ADDENDUM TO RI/FS WORK PLAN
NAVAL AIR STATION, BRUNSWICK

JOB NO. 4607-06

JULY 1988

1.0 RESPONSES TO USEPA CONDITIONS FOR APPROVAL

**FIGURE 1
RI/FS PHASE I + II SCHEDULE
NAS BRUNSWICK**

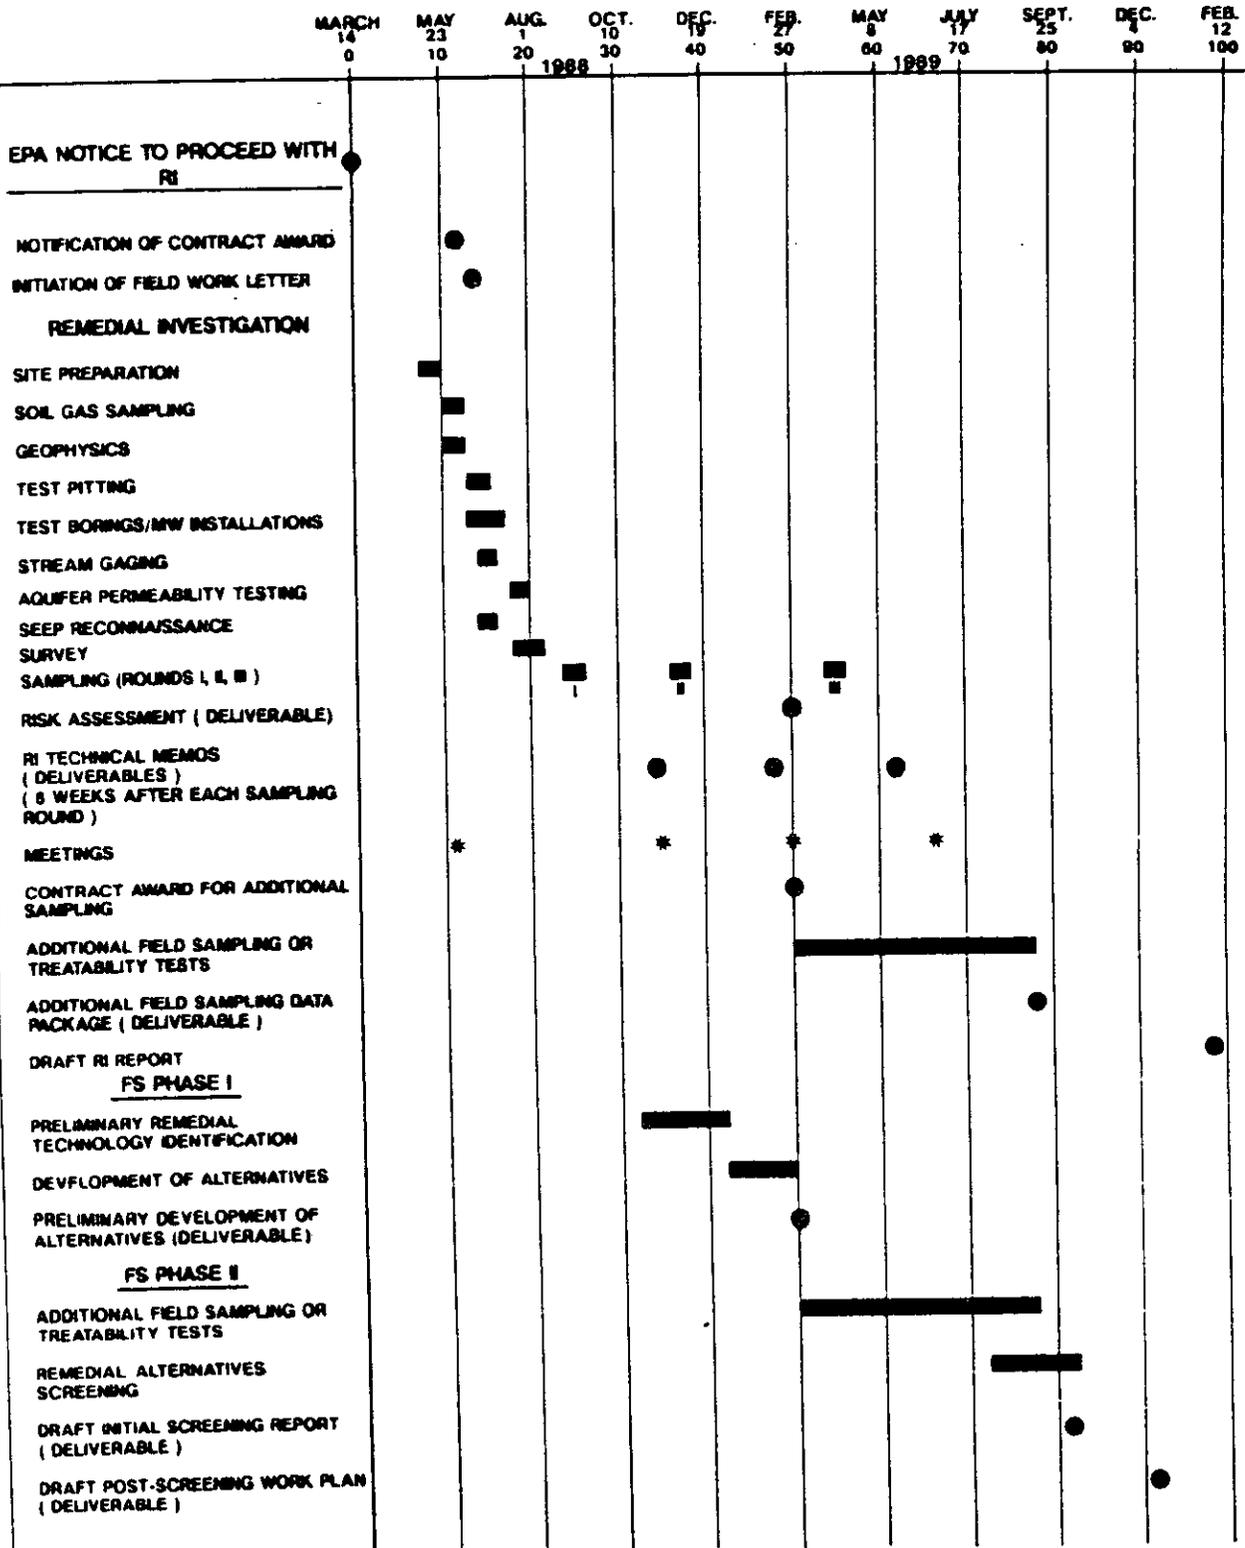
<u>Page Number</u>	<u>Recommendations</u>
2-2	Modify the schedule for the RI/FS to reflect the schedule for sampling as discussed in the TRC meeting of May 17, 1988.
4-3	Provide maps to EPA for locations proposed for soil gas survey for each site. Describe grid network spacing, depth(s) to be sampled, timing of sampling after precipitation, and QA/QC procedures.
Table 4-2 4-4	Justify numbers shown for the maximum estimated sampling points.
4-8	Based on the results of the first phase of the RI field work, consider the installation of shallow well points at the following locations: MW-101, 401, 703, 804, 901, 903 in order to obtain water level and chemical data in the shallow water table aquifer. These could be stainless steel driven points.
Figure 4-1 4-9	Mark the measuring point on PVC casing
4-10	Indicate methods of aquifer permeability test data analyses to be used. Provide references.
4-11	Realign a portion of seismic line 2 to provide more information upgradient (west) of site 2. DC resistivity soundings should be considered for the next phase of field activity at strategic locations along the new lines.

<u>PAGE NUMBER</u>	<u>JORDAN RESPONSE</u>
2-2	Modified project schedule attached (see Figure 1).
4-3	Maps of soil gas survey points will be provided by Jordan with a discussion of QA/QC procedures used in the field.
Table 4-2	
4-4	The soil gas program was completed on July 14, 1988. The proposed maximum number of sampling points was exceeded by 25%. The number of sampling points was estimated based on the size of each site, known methods of disposal, and on the contaminants anticipated from previous investigations.
4-8	The installation of additional shallow well points based on the Phase I RI field work will be considered.
Figure 4-1	
	The measuring point for water levels in monitoring wells will be marked on the PVC well risers.
4-10	The method of analysis to be used for aquifer slug test data analysis will be Hvorslev, M.J., 1951, "Time Lag and Soil Permeability in Groundwater Observation," U.S. Army Corps of Engineers Waterways, Experiments Station Bulletin 36, Vicksburg, Mississippi.
